# AIRWORTHINESS ADVICE NOTICE

CFA/AN 58

BRASOV 2

Miscellaneous reported defects.

WING ROOT LOCATING PINS - CRACKS

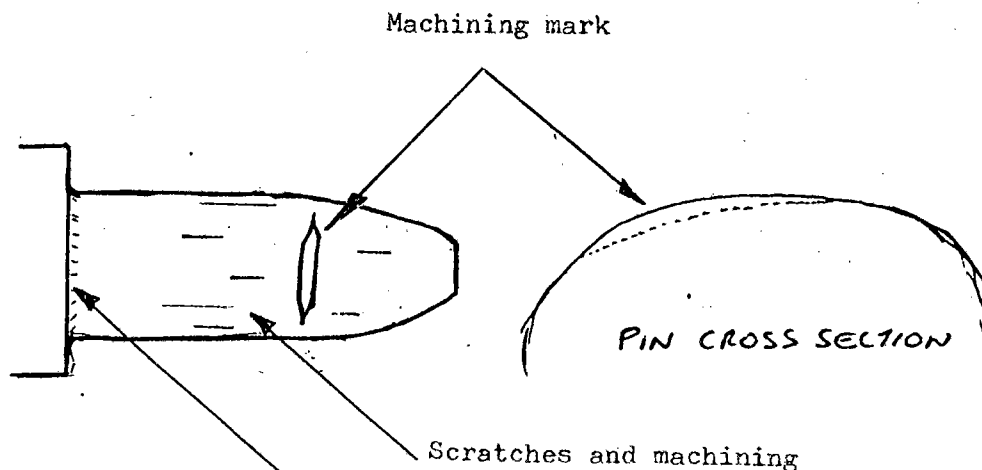
Badly machined wing root locating pins have appeared to be cracked. Under magnification and dyecheck proven to be scores or scratches. If the scoring extends into the radiused area at the root of the pin, cracking may develop with time.

Pins should be checked at Form 2 inspections.

Any defects in the radiused area need to be inspected in more detail.

### DEFECT No. 3      PUSH ROD BENDING/CRACKING

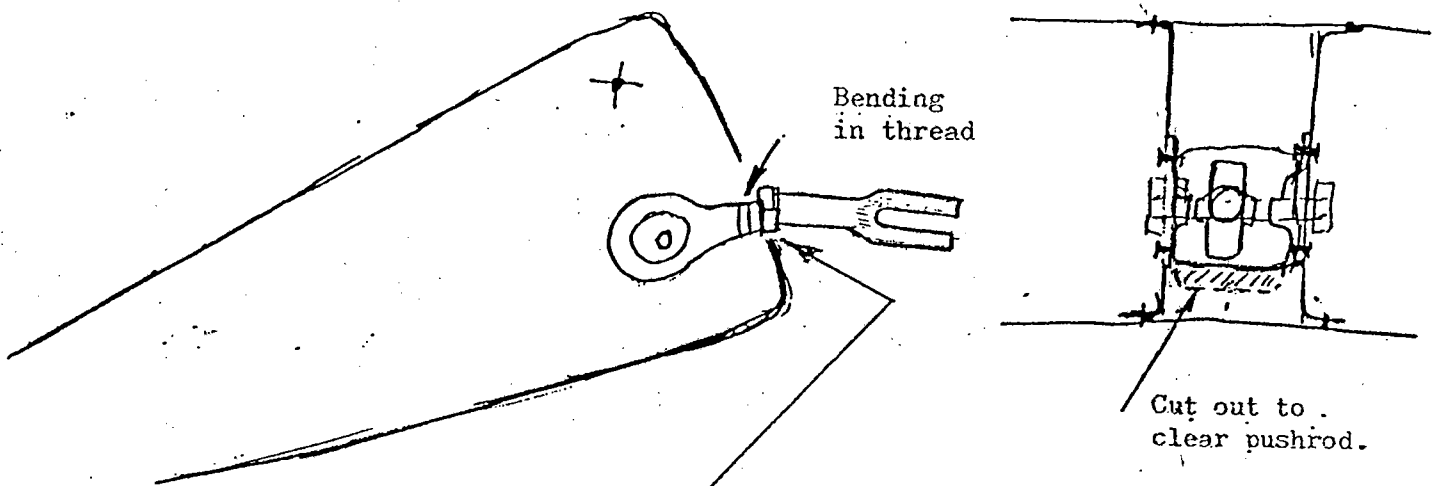
Most IS28B2s end up with the short push rod linking the aileron to the bellcrank measuring 95mm with the ailerons moving through their correct travel. In 4 cases reported the pushrod has interfered with the aileron leading edge cutout and bent rod has resulted.

Bending will occur if aileron leading edge is not relieved after adjustment of push rods on some gliders.

Ensuring that control systems are free of interference is part of a C. of A. inspectors responsibility, therefore this defect should never have occurred.

### DEFECT No. 4      RIGGING OF DIVEBRAKE & WHEEL BRAKE

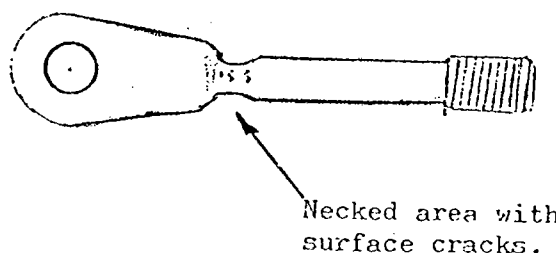
An accident involving an overshoot highlighted the possibility of rigging the wheelbrake such that it restricts the dive brake travel excessively. (Not all IS82B2s have interconnection). The dive brake extension can be restricted by over 50mm, to achieve good wheel brake operation, with some loss in dive brake effectiveness. Any operators who wish to fit a separate wheelbrake should discuss it with the GFA CTO/A. A suitable modification would obviously allow both systems to perform more effectively.

DEFECT No. 6. AIRBRAKE SYSTEM ROD ENDS

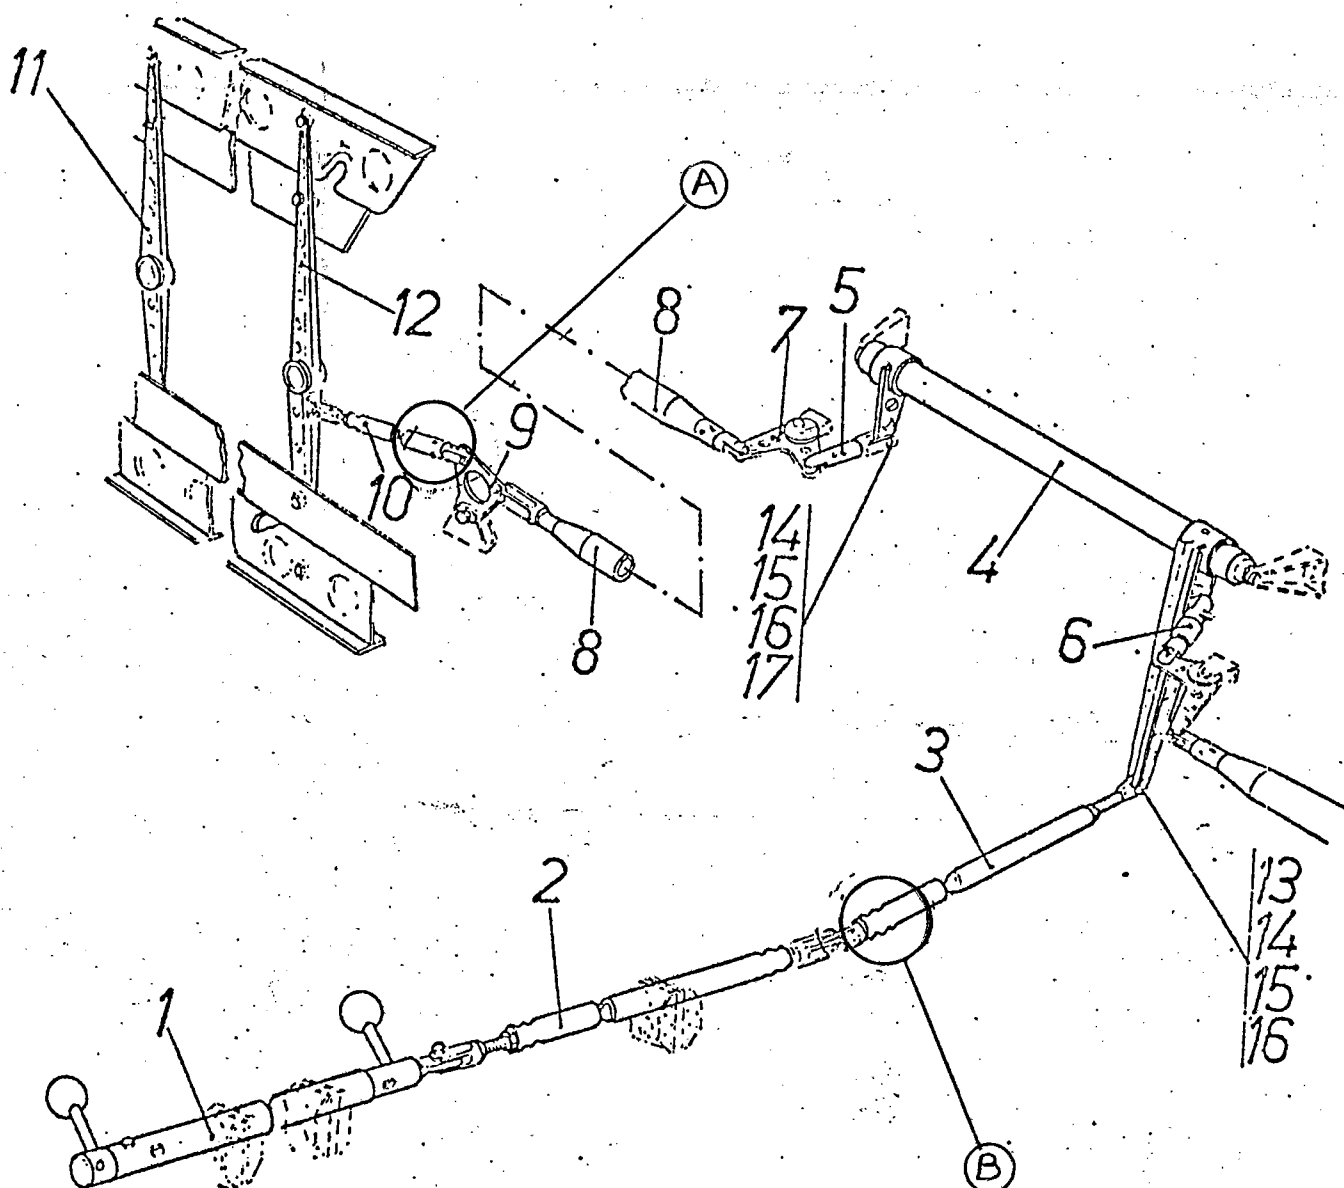
The rod ends at (a) and (b) are crimped. These have been found loose in service and rectified by drilling, reaming and through bolting with AN3 or similar bolt and locknut. Interference of bolt heads and nuts must be checked through full movement of the airbrake control system. Some serial numbers may have been bolted in production.

DEFECT No. 7 AILERON SYSTEM "OVERCENTREING"

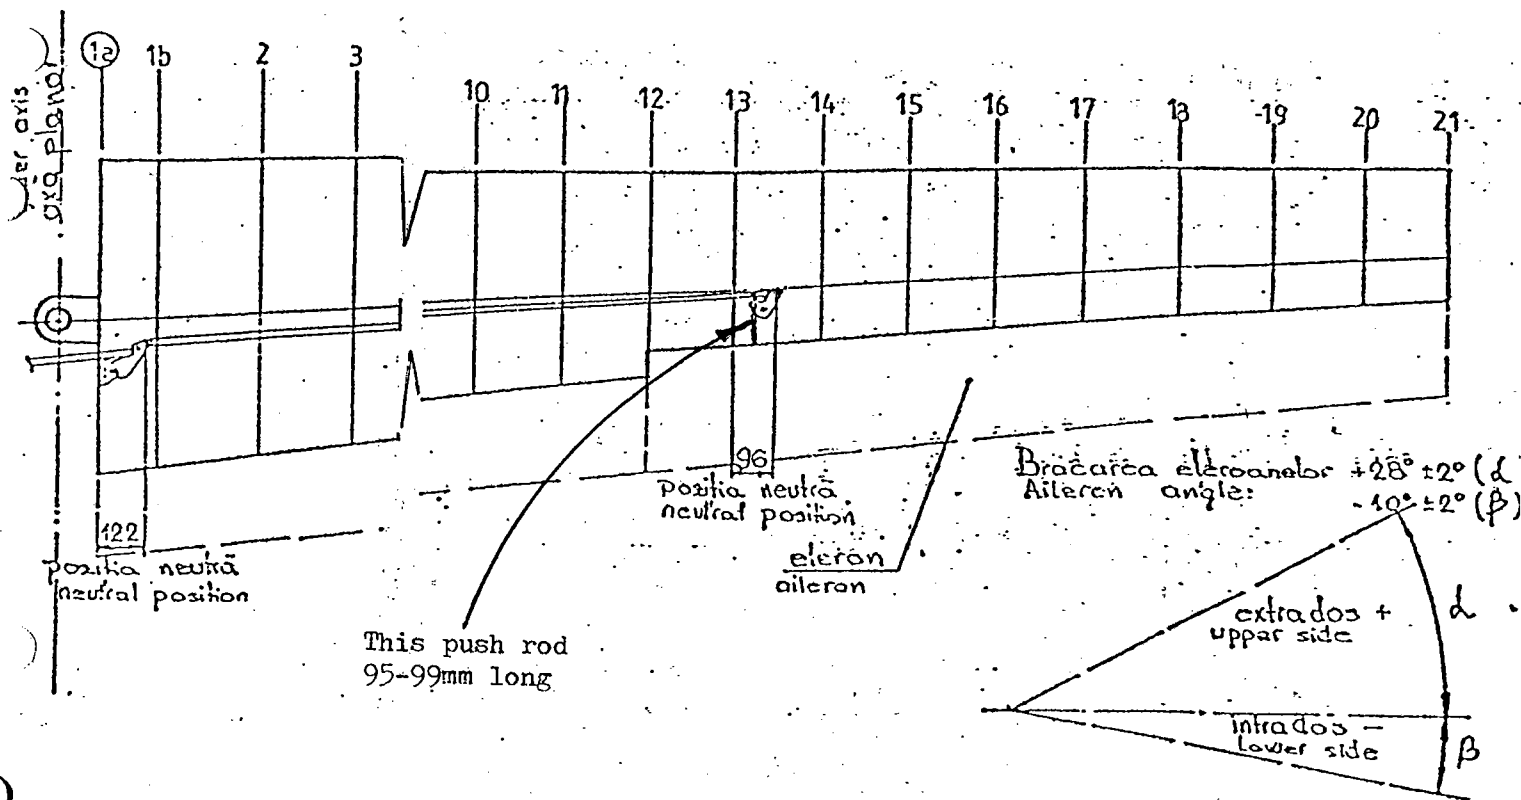
Many operators have experienced a tendency for the ailerons to become heavy and feel as if the system is moving "overcentre", overpowering the pilot to some extent. Most prevalent during aerotow and in rough air.

Causes of this unpleasant control feel are many and varied:-

- (1) Breaking of the stringing holding the fabric to the underside of the aileron ribs. This will have an aerodynamic out of balance, particularly where only part of one aileron comes free. Where all of the fabric on both ailerons hangs free it does not appear to have an adverse feel.

(2) The diagram supplied in AD 198 was wrong as supplied by the factory (Twice). The link joining the aileron to the bellcrank has been found by field experience to measure 95-99mm with the correct aileron travels, not 105 as proposed by the factory. It seems likely that individual sailplanes will show variations in these dimensions.

(3) The rear control column connects under the left side cockpit floor, via a short push pull rod to an alloy plate bellcrank which redirects the control circuit rearwards.

The short push rod has a fork end fitting, into which the bellcrank fits. We have found substantial interference on some gliders between the fork and bellcrank, which required machining of a 45° chamfer on one edge of the bellcrank to clear the fork. This removed most of the adverse feel present in those sailplanes.

A common method of rectification is to apply an alloy strip, the width of the rib flange, over the outside of the fabric and pop rivet through strip fabric and rib.
